Re: Second Submission Review – Kings Point North West – Site Plan (ISP)
Application Number: **DA-1609-20**
Case Numbers: **2021-6058-00**

Second Submission Review

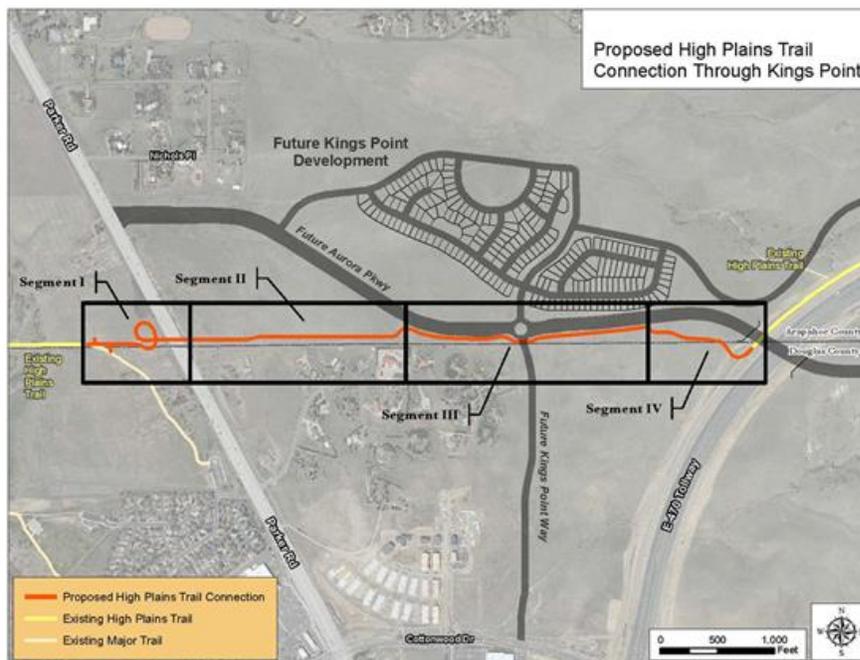
The proposal to construct a soft surface or crusher fines trail is not supported by the Partners. The High Plains Trail Partners request that COA require the entire High Plains Trail, Segment III (refer to the below graphic), be constructed as a hard surface as per the horizontal and vertical alignment for the sidewalk shown in the Kings Point North - West Infrastructure Site Plan. This is a regional trail serving thousands of users. The connection east on Segment III is essential for the residents to the north and northeast to

access the Cherry Creek Trail. A soft surface trail is an unsuitable surface for road bikes with thin tires and roller blades. Also, it is unknown when the eastern portion of Aurora Parkway and bridge over E-470 will be constructed; this “Temporary” trail segment east of the roundabout could be in place for many years.

Arapahoe County and City of Parker formally request a concrete trail be constructed for the entire trail in Segment III in the final alignment, as shown below. Construction of the entire concrete trail in segment III, in final location and alignment will avoid future conflicts, closures and detour requirements when this section of Aurora Pky. is built. If a temporary trail is built, in the future the entire area will need to be closed for months for grading and construction and a detour will be needed.

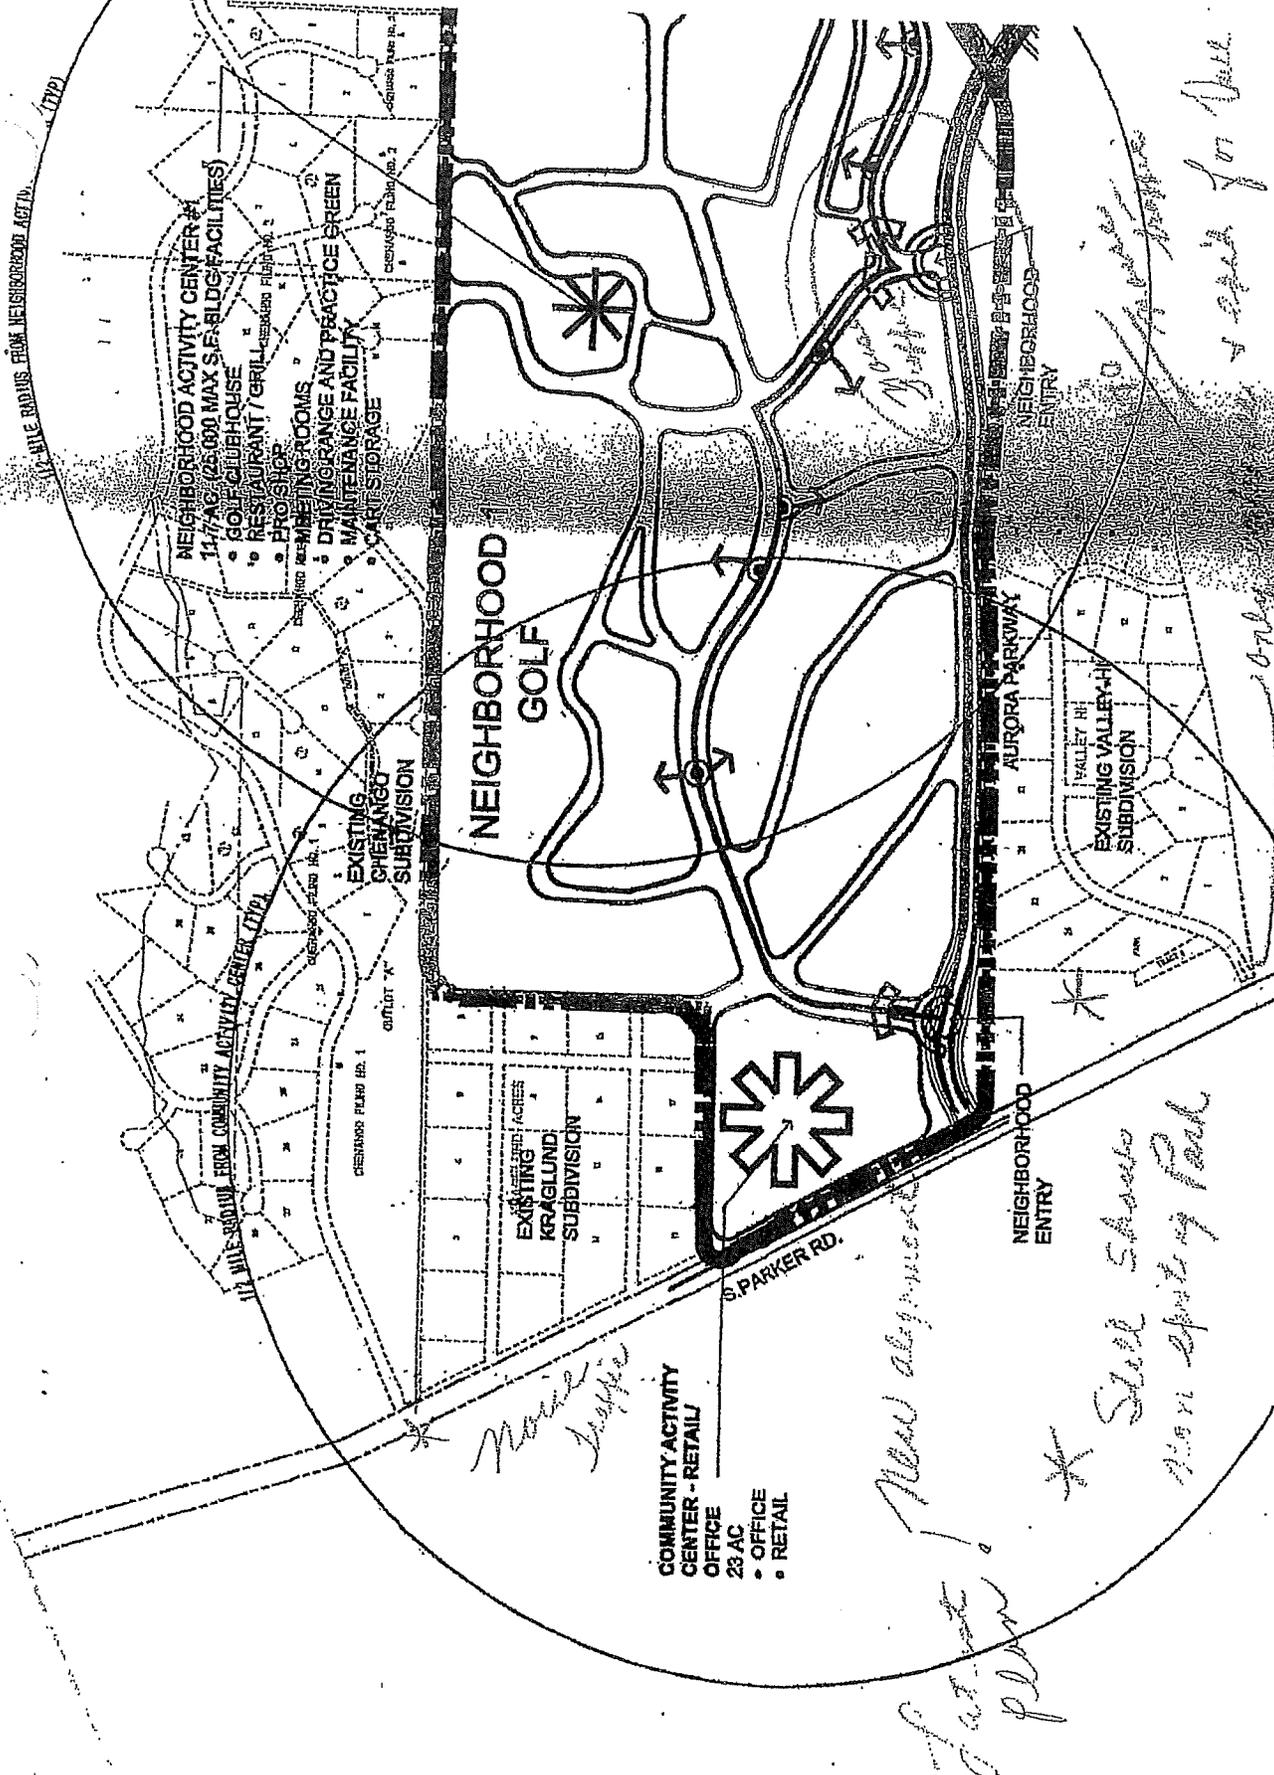
Put in a new alignment plan
